Safety Alert 11-19

## **Marlin PFD Recall**

Figure 1: Incorrect label of Adult Model 320RT (160.055/215/0)

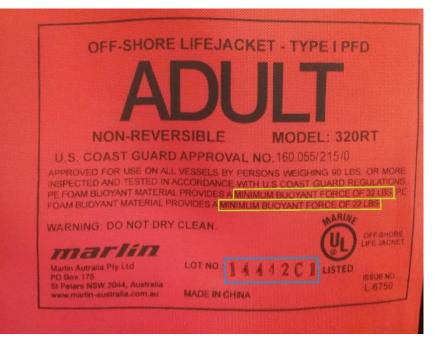
Adult Model 320RT (160.055/215/0) incorrectly lists a minimum buoyant force of 32 pounds; the correct minimum buoyant force is 22 pounds. Child Model 321RT (160.055/216/0) incorrectly lists a minimum buoyant force of 16 pounds; the correct minimum buoyant force is 11 pounds. Figure 1 shows the incorrect Adult Model 320RT label.

Starting June 19, 2019, all Model 320RT and Model 321RT PFDs have been manufactured with the correct labels. The first lot number of Model 320RT with corrected labels is 19001; the first lot number of Model 321RT with corrected labels is 19002.
